# PROPOSED DHL FACILITY - ELIZABETH DRIVE BADGERYS CREEK NSW- STAGE 1 SSDA

## VISUAL IMPACT ASSESSMENT

## 12 RESPONSE TO DEPARTMENT'S REQUEST FOR INFORMATION (RFI)

Figure 12-2 Selected viewpoints (Including new viewpoints) – 2km radius

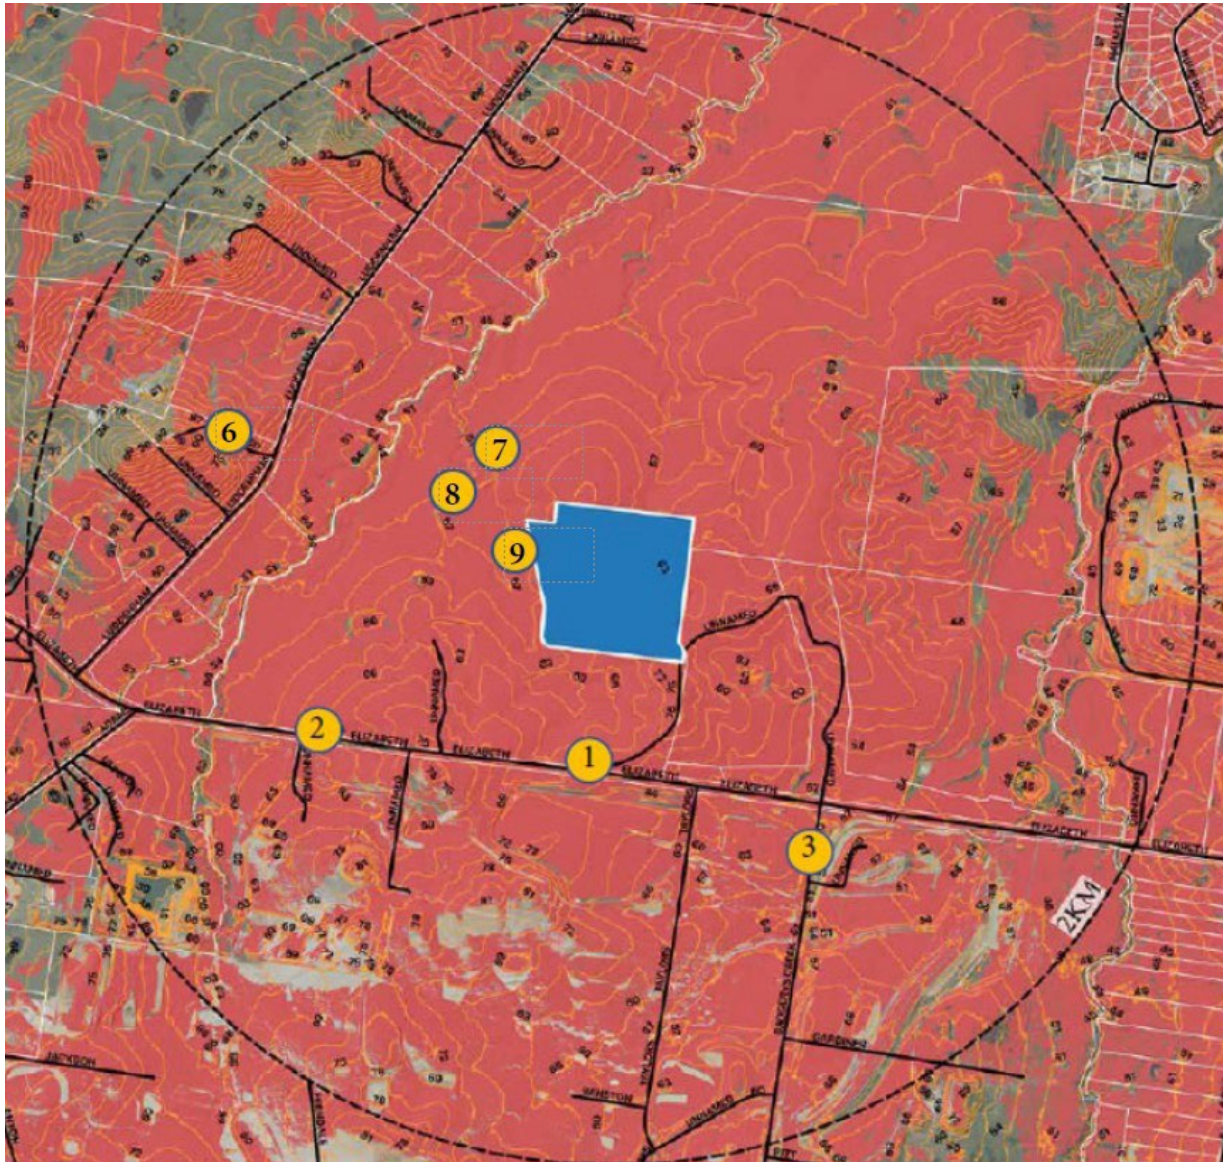
*Clarify why Viewpoint 4 was selected further north along Luddenham Road, rather than closer to the site or from properties that may overlook the site from a higher elevation (e.g. 821 Luddenham Rd or 676 Luddenham Rd).*

Four additional viewpoints have been selected to address the Department's request for additional information (Figure 3-1). One of these (viewpoint 6) is located on the private access road to the Luddenham Raceway site. It has been chosen as a representative view to the site from elevated properties on the western side of Luddenham Road. The other three views (viewpoints 7, 8 & 9) are from indicative locations within the boundaries of on Burrah Park estate.
